ARC Compliance Report

Demo elements | Generated 2026-08-02T12:20:01.266884+05:30

Model	Demo elements	Stage	concept
Source	Demo elements	Run context	CLI (headless)
Model Path	n/a	Rule Preset	custom
Rules Path	arc\core\rules	Compliance	92.9%

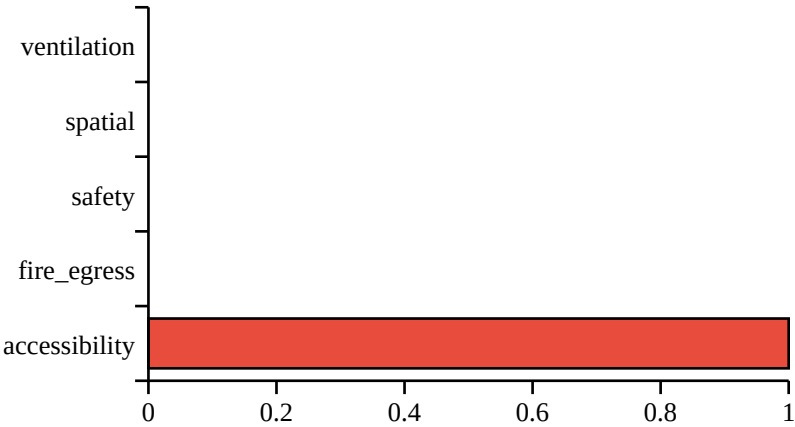
Spatial conflict findings	1	Route analyses	0
Unique blocker elements	2	Longest route	—

1. **nbc_acc_01** | Element: door1

Status: FAIL | Severity: critical | Category: accessibility

Message: Wheelchair approach blocked: 2 modeled obstruction(s) intrude into the required manoeuvring zones on both pull/push assignments

Blocking Elements: railing1, stair1

Suggestion: Clear the approach zones on both sides of the door or relocate the obstructing elements.
